AGENDA

Greater Asheville Regional Airport Authority Regular Meeting
Friday, October 17, 2025, 8:30 a.m.
Council Chambers at Fletcher Town Hall
300 Old Cane Creek Road, Fletcher, NC 28732

D. Approval of Construction Contract Change Order No. 7 with Kokolakis Contracting for the Air Traffic Control Tower and Associated Facilities Project and Approve Owner Allowance Project Items (**document**)

E. Approval of Change Order No. 8 with Hensel Phelps for a Tower Crane and the Addition of a Construction South Access Road (**document**)

RFI#254.1 (4/10/25)
Design conflicts depicted in **red** **(ELEV. 100'-0" to 107'-0")**

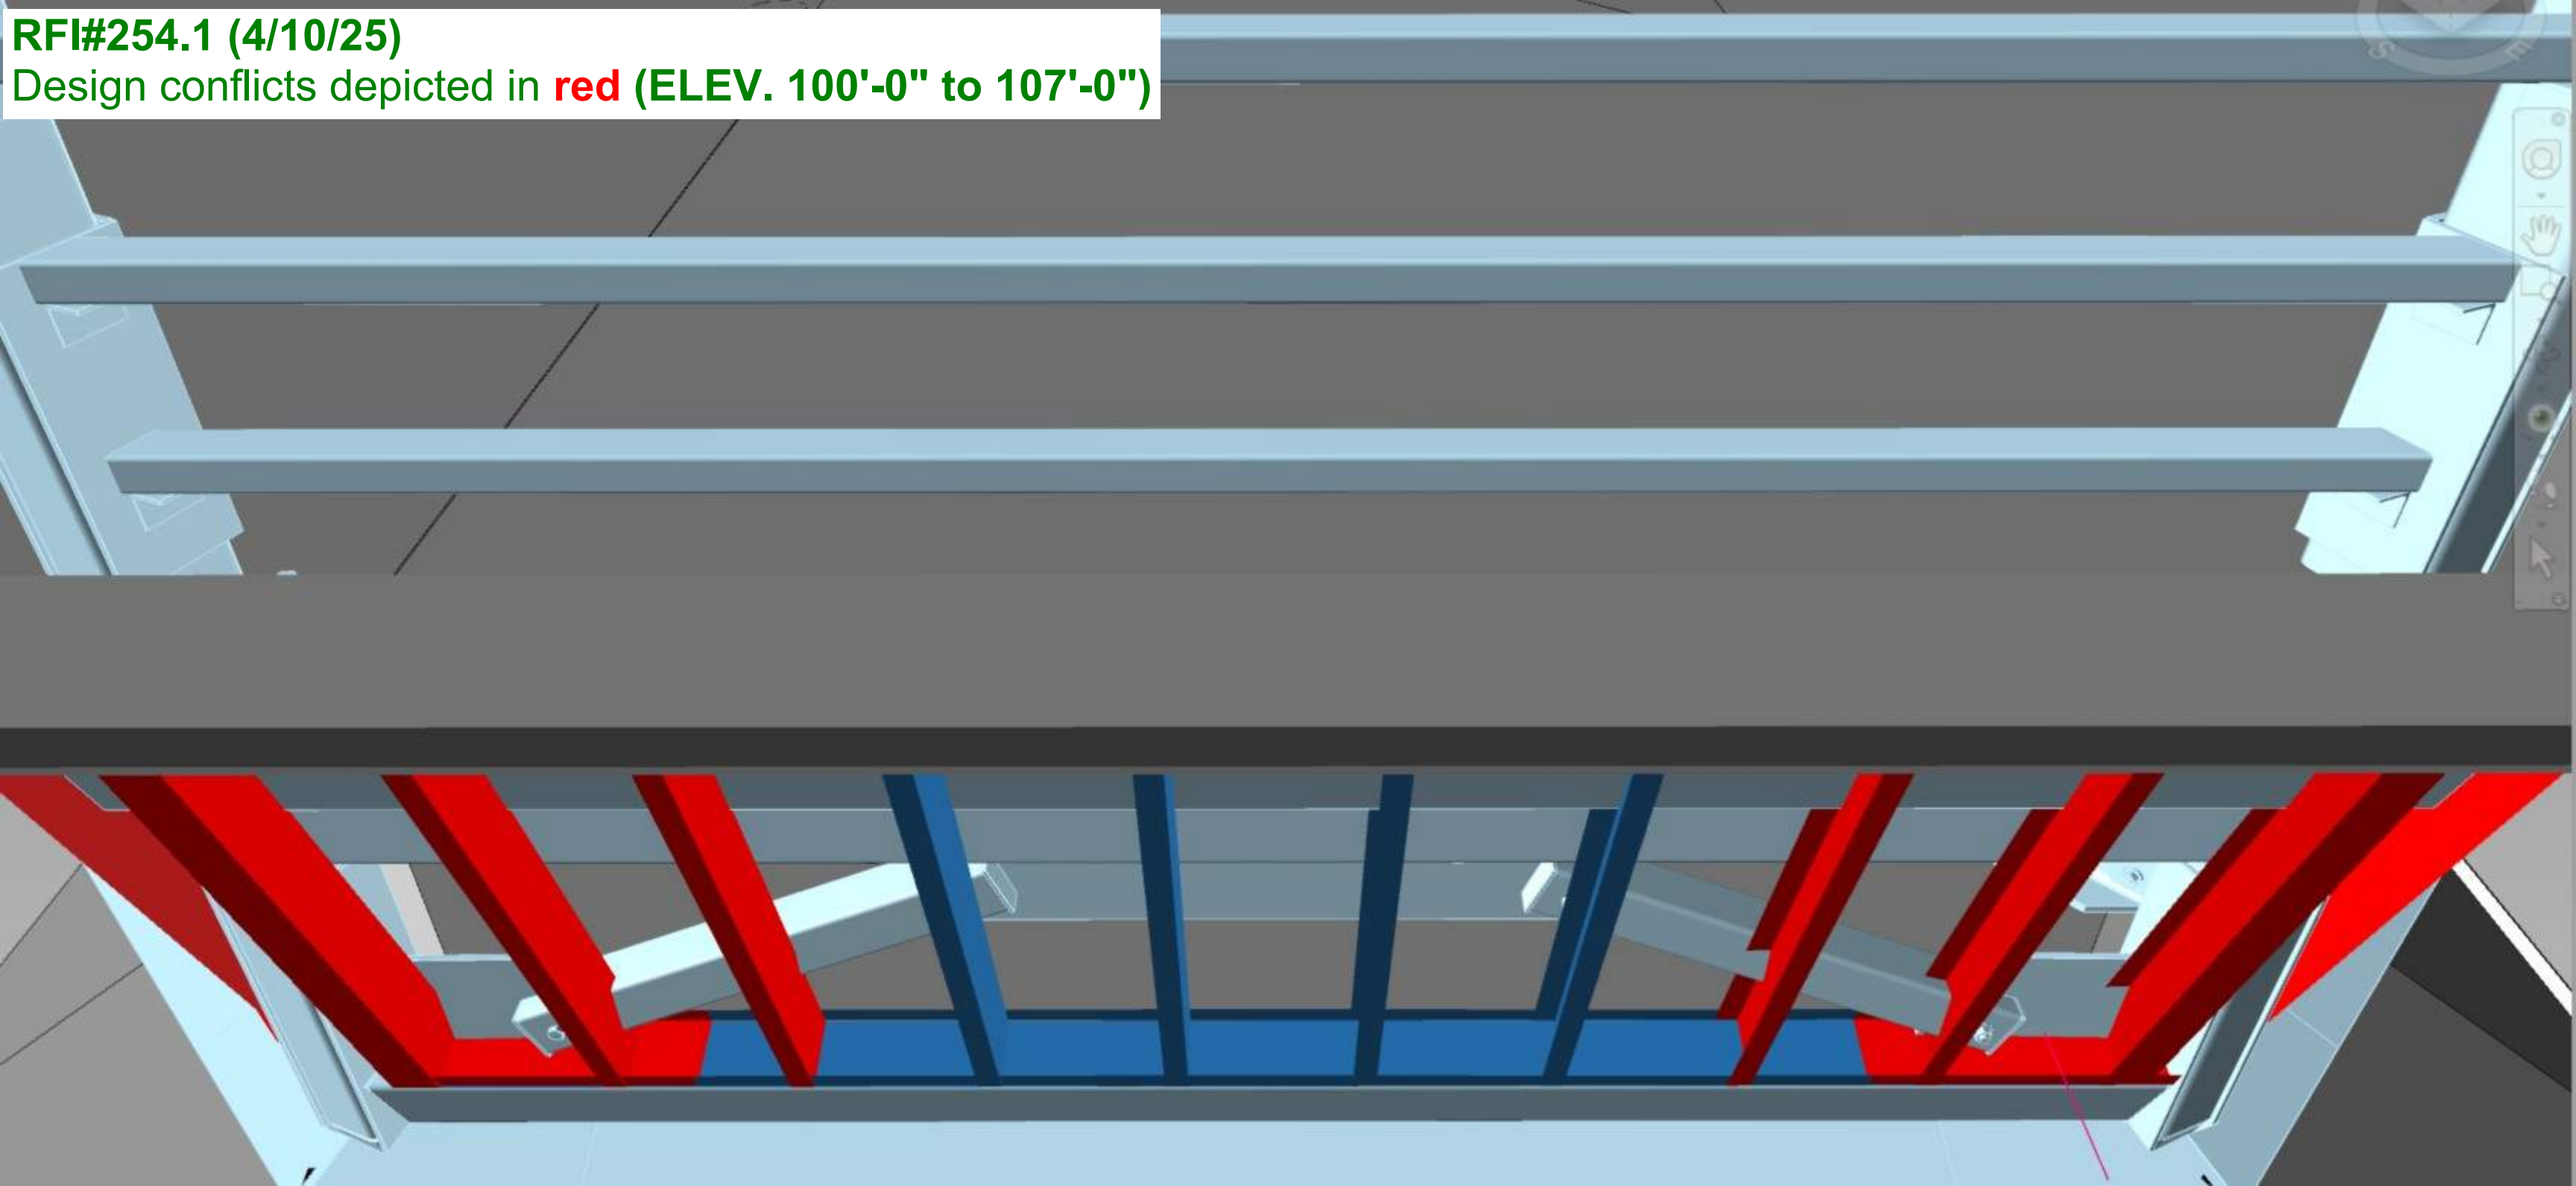
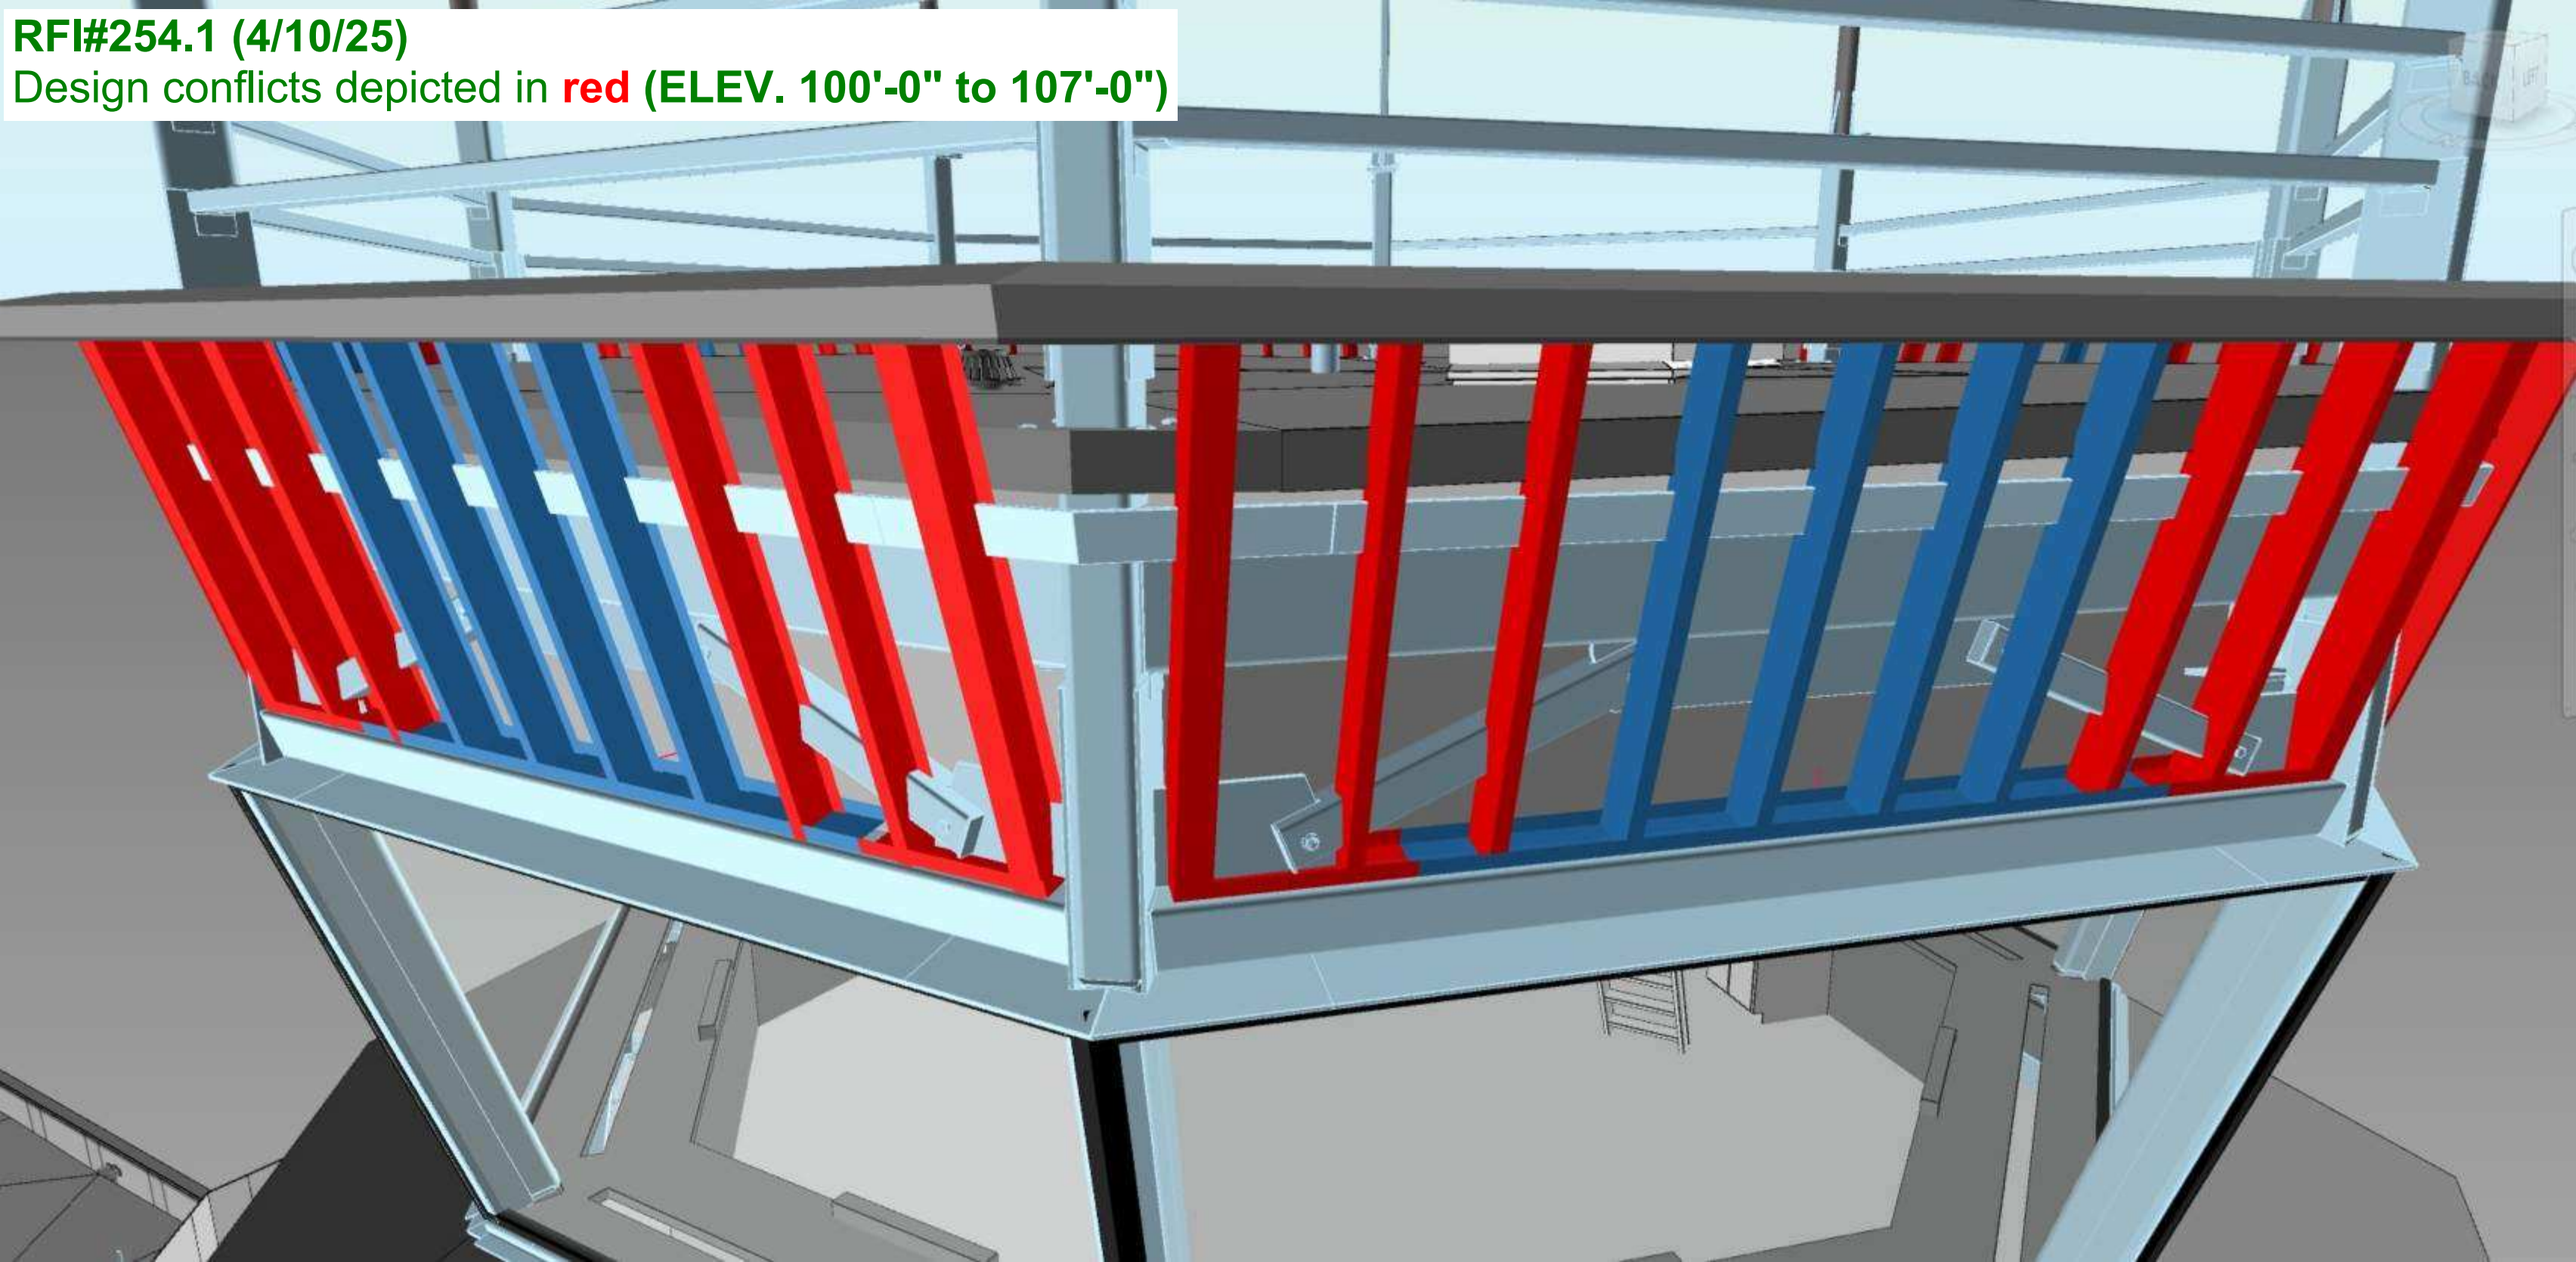
DESIGN STRUCTURAL STEEL BRACED FRAMES CONFLICTING WITH DRAWING A-361 / DET. A4; DRAWING A632 / DET. D1

RFI#254.1 (4/10/25)
Design conflicts depicted in **red** **(ELEV. 100'-0" to 107'-0")**
